PLANNING, ZONING, & BUILDING DEPARTMENT
PZ&B Staff Combination Memorandum: Architectural Commission and Town Council

SUBJECT: ARC-24-0023 (ZON-24-0010) 515 N LAKE WAY (COMBO)

MEETING: JUNE 26, 2024, ARCOM
JULY 10, 2024, TC

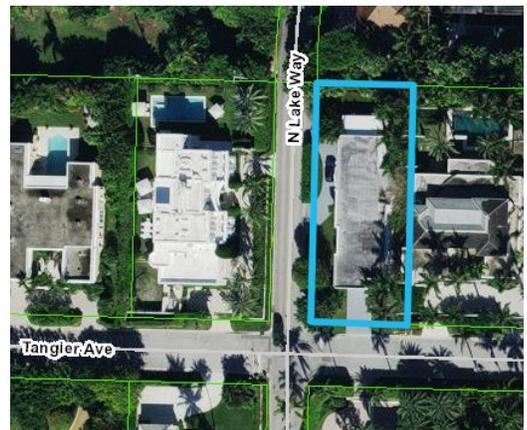
Staff had initially expressed concern that per Section 134-2197 supplemental parking spaces not located within an enclosed garage structure shall require effective screening by hedges and/or a wall permitted by the Code not less than six feet in height, shall be placed between said off-street parking and any street and/or interior lot lines was not being met. However, the applicant has added appropriate landscaping while maintaining the visibility triangle.

(graphic of site plan rotated 90° for visual reading ease)

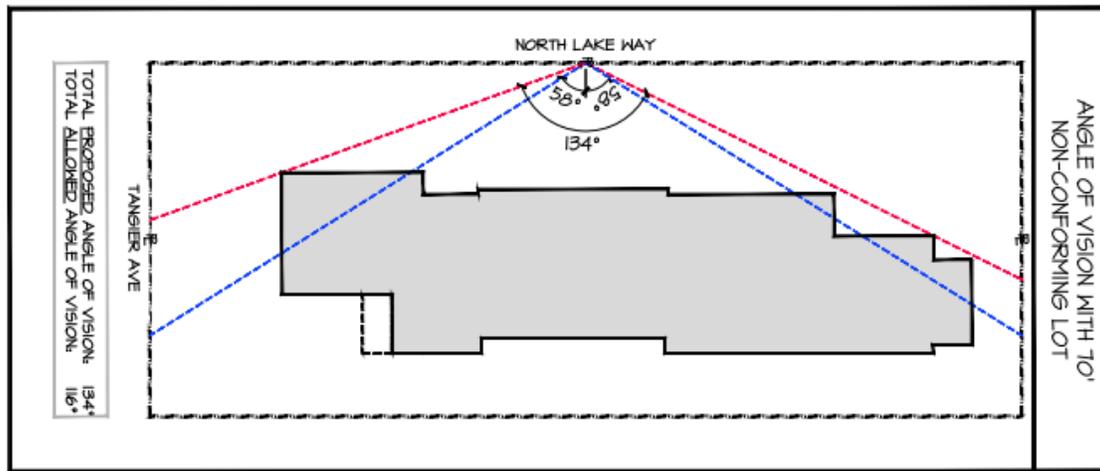
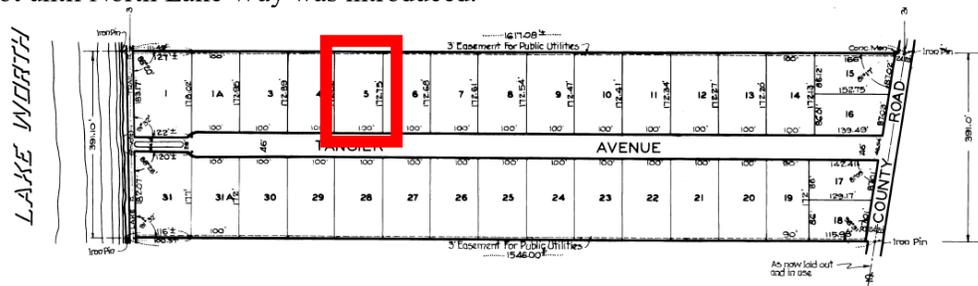
The Angle of vision zoning regulation is a tool intended to complement the setback requirements by ensuring that the mass of the building is ‘pushed back’ from the street, at least visually, by creating this additional step back regulation. This regulation is mostly applied to the north or south facade face of the residences due to the long linear layout of the Island, having mostly east-west streets developed with residences. When applied to corner properties, or those with more unique configurations, such as the subject property—compliance is more challenging. In this specific instance, the width of the lot along N Lake Way measures over 172’ in length making it very challenging to comply with the wide aperture of the angle of vision; yet the code specifically requires such; *In the case of corner lots or through lots*

with frontage on the following primary north-south roadways, the building angle of vision shall be applied only to the frontage along the designated primary north-south roadway: North Ocean Boulevard; South Ocean Boulevard; North County Road; South County Road; and North Lake Way.
